44470A-01**S E R V I C E N O T E**Supersedes:
NONE**44470A** 10 channel multiplexer module for 3499A/B. Includes a screw terminal block**44471A** 10-channel General Purpose Relay for 3499A/B. Includes a screw terminal block**44473A** 4x4 Matrix Module for 3499A/B. Includes a screw terminal block**44474A** 16-bit Digital I/O Module for 3499A/B. Includes a screw terminal block**Serial Numbers:**

Defective connectors shipped with 44470A, 44471A, 44473A, 44474A

Figure 2: Good Connector with alternating pins on top and bottom

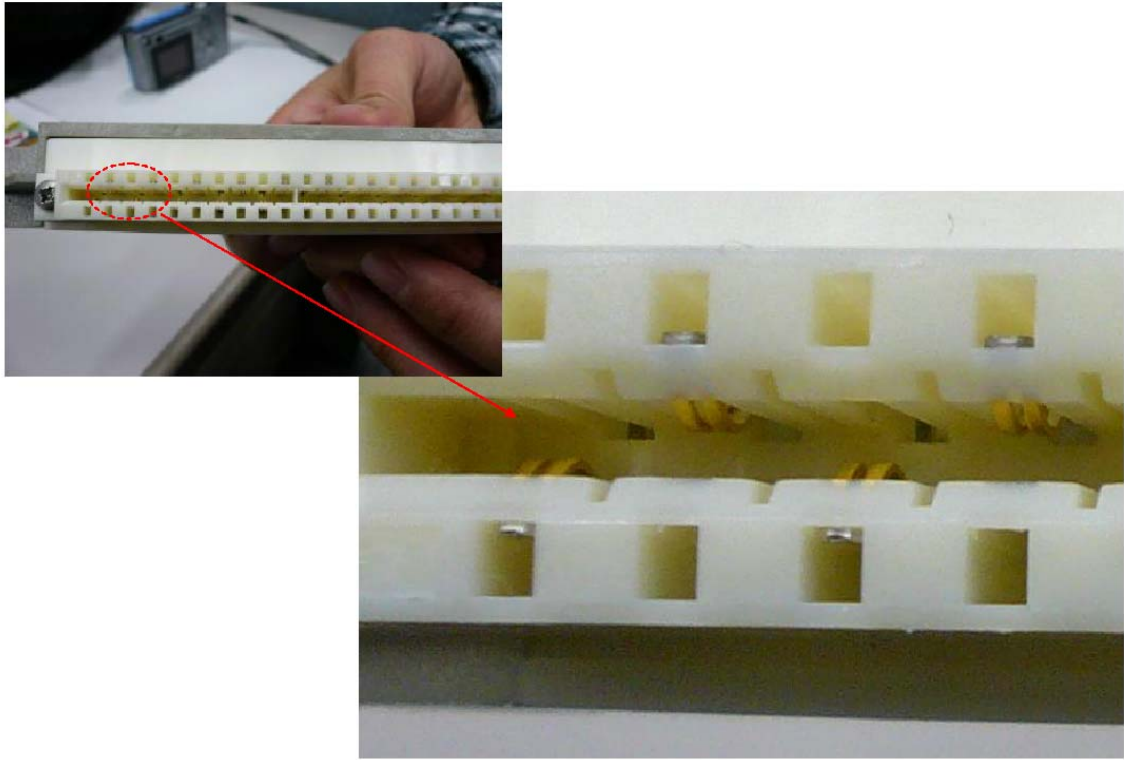
The 44470A, 44471A, 44473A, and 44474A products consist of a main relay plug in module and a removable terminal block (see Figure 1). These are plug in modules for the card cage mainframes 3488A, 3499A, 3499B, and 3499C. The main relay card contains the serial number. The removable terminal module does not contain a serial number. A visual inspection of the connector in the removable terminal block is necessary to determine if a defective connector is present. All white colored connectors are good and have pins that alternate top to bottom (see Figure 2). A black colored connector is bad if it contains all pins on one side of the connector (see Figure 3). A black colored connector is good if it contain pins that alternate top to bottom (not pictured).

Figure 3: Defective Connector with all pins on one side

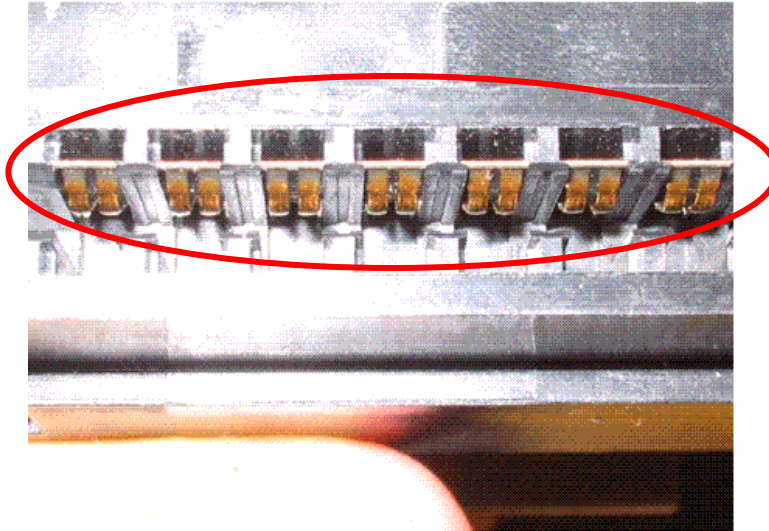
The 44470A, 44471A, 44473A, and 44474A contain a main relay card and a removable screw terminal block (see Figure 1). Some of the removable terminal blocks that were shipped between 1-Jan-2008 and 08-April-2008 have a defective connector that results in half of the pins being unconnected.

The procedure to correct the defective connectors is very simple. One must replace the defective connector with a good connector (see connector part numbers list on page 2). The customer may perform this procedure or have an Agilent-qualified person perform this procedure.
